Memorandum

To Kingston Council Date 30 November 2021
From [REDACTED] Job no 046355
Copied to Harsha Bhundia, [REDACTED]
Subject CRE Energy Statement Review and suggested wording

This note summarises a review of the heat network strategy within the Energy Statement for the Cambridge Road Estate development and makes suggestions of possible Section 106 conditions to be included.

Figure 11 from the CRE Energy Statement - highlighted area for thermal stores which will not be required if connecting to DHN and this space may be able to accommodate additional plant

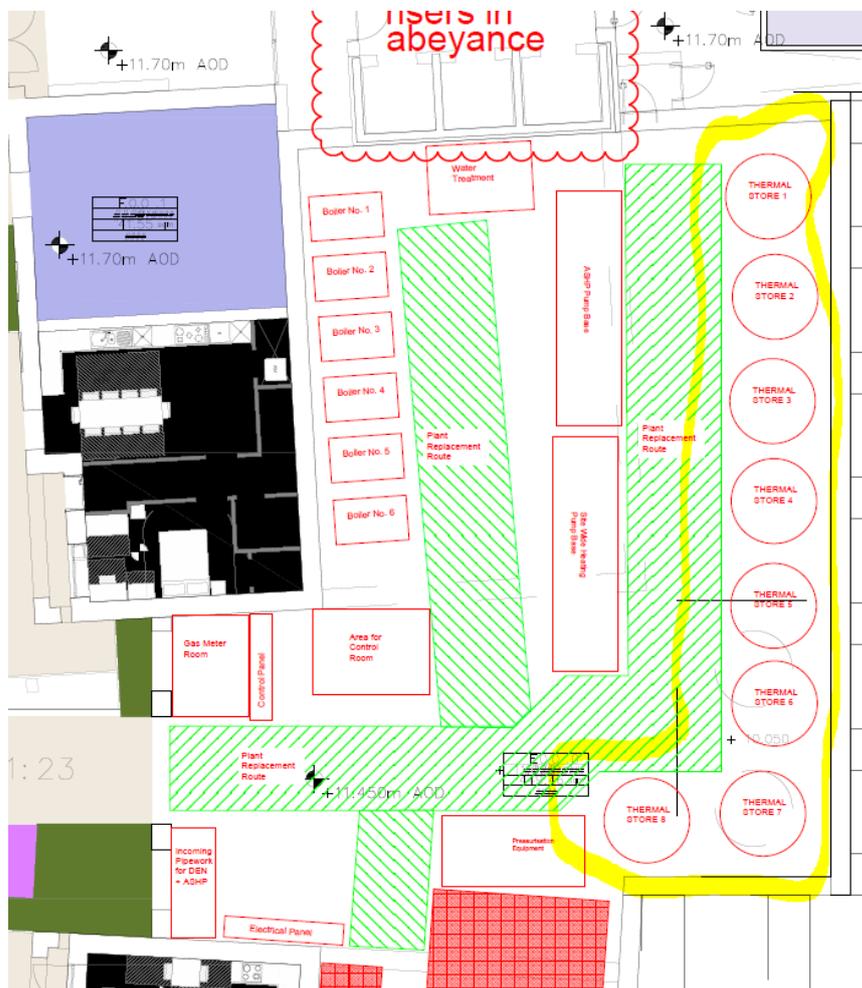
- Figures 8 (p30) and Figure 11 (p33) in the Energy Statement illustrate the energy centre options depending on the final energy centre solution. The following highlighted screenshot of Figure 11 illustrates the additional space that will be required in the alternative on-site solution (mostly taken up by thermal storage).

- This space could potentially be used to accommodate additional peak heating plant on the KDHN. It would be recommended to request that sufficient fluing space is provided for further boiler capacity should the heat network need it.

- The alternative low carbon on-site solution requires safeguarding for a larger energy centre (to accommodate heat pumps and thermal storage). The Developer shall ensure that this space can be adapted to accommodate additional boiler capacity including provision for additional space for flues within the energy centre risers. The Developer will not be expected to install the additional plant.
